Application of Oncor Electric Delivery Company LLC
for the Ramhorn Hill to Dunham 345 KV Transmission Line

PUC of Texas Docket #55067

Statement of Position

PUC Docket 55067
Regarding Segment M8
and
FAA Form 7460-1

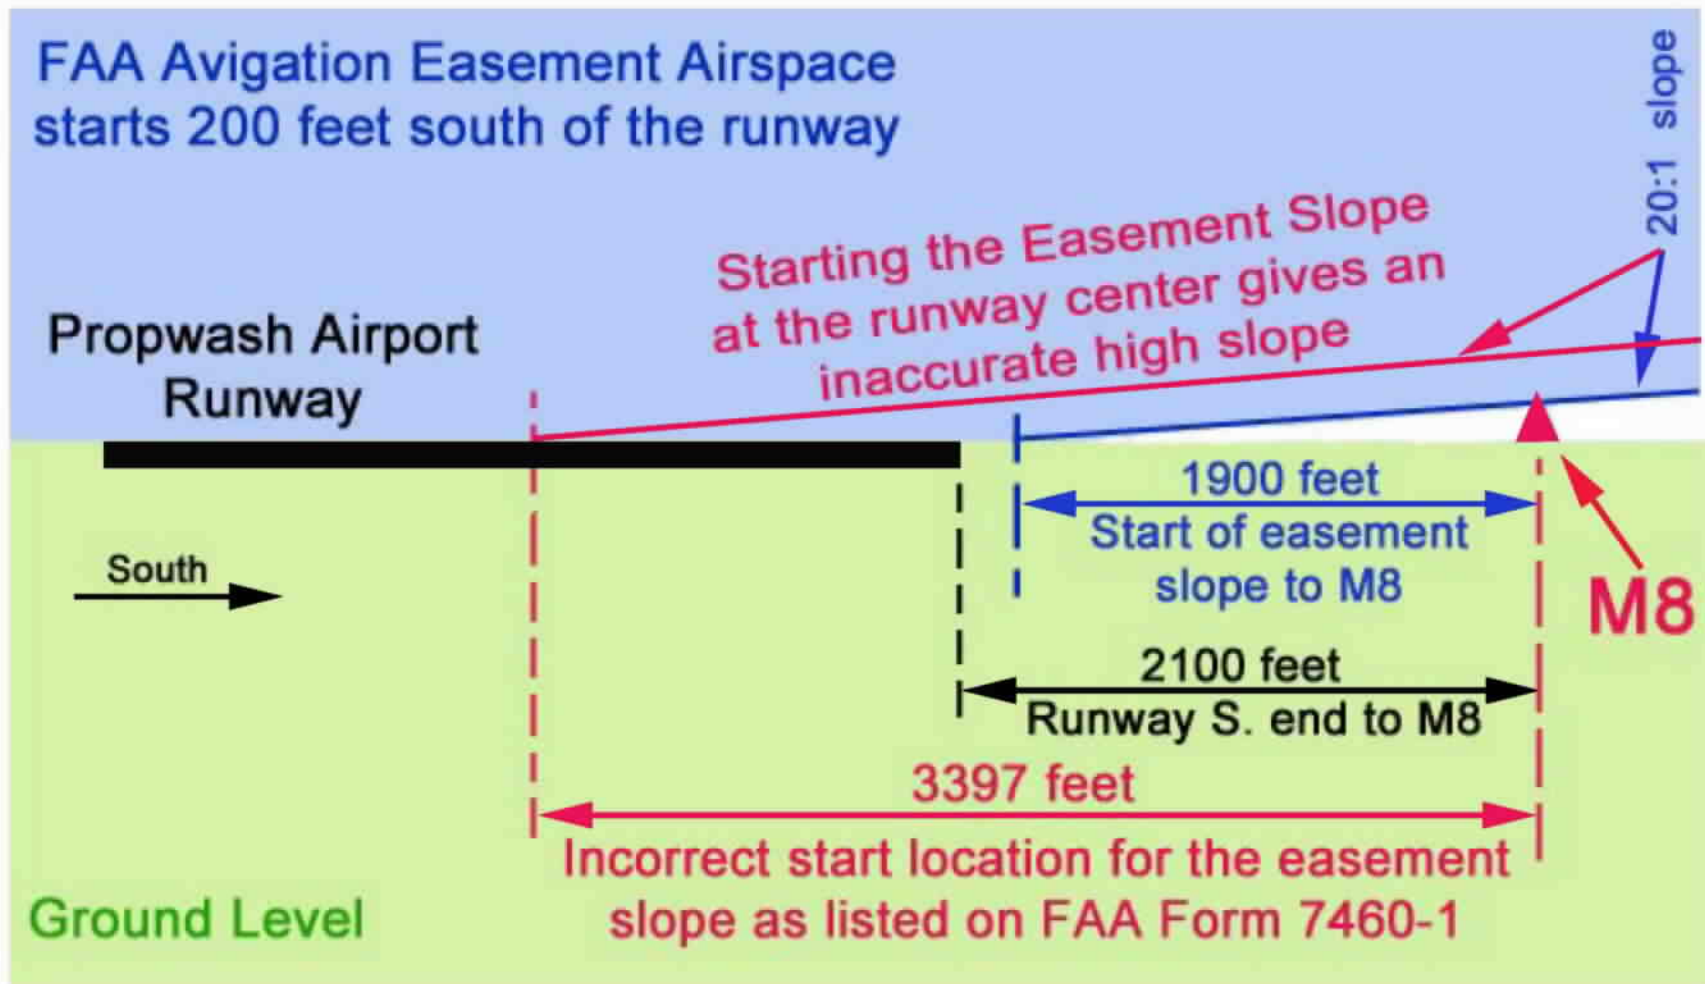
This drawing is a simplified side view of the Propwash Avigation Easement. The black bar represents our 3,000 foot long runway. I used the runway as a gauge to make all other measurements as close to scale as practical.

Using my GPS to measure the distance from the south end of the Propwash Runway to M8 I got approximately 2100 feet (represented by the black text and arrow).

Subtracting the FAA 200 foot start of slope point, from the 2100 feet we get 1900 feet. 1900 feet is the distance from start of the easement slope to M8 (represented in blue text and a blue sloped line).

The ground is shown shaded in green. The red triangle represents a scale model of M8 at 120 feet tall. 120 feet is the shortest tower on the Oncor "Typical Double Circuit 345 KV Steel Pole" handout (see page 5). Elevation in the M8 area is 15 feet lower than the Propwash runway. If you look carefully the red M8 triangle is set down into the green to compensate for the lower elevation at M8. Even the short M8 towers will penetrate the Avigation Easement (blue line).

On FAA Form 7460-1 for ASN 2022-ASW-22411-OE, Oncor listed the "Distance to Structure" as 3397.2 feet. 3397 feet is the distance from the center of the runway to M8. Starting the easement slope at the runway center gives an error in the slope over M8 that is about 74 feet too high. This case incorrectly shows that M8 is below the Avigation Easement. The incorrect slope is shown with red text and lines.

This shows that even the shortest tower is a "Hazard To Air Navigation" and that route M8 will put not only aircraft but the surrounding community at additional risk and therefore I am opposed to M8.
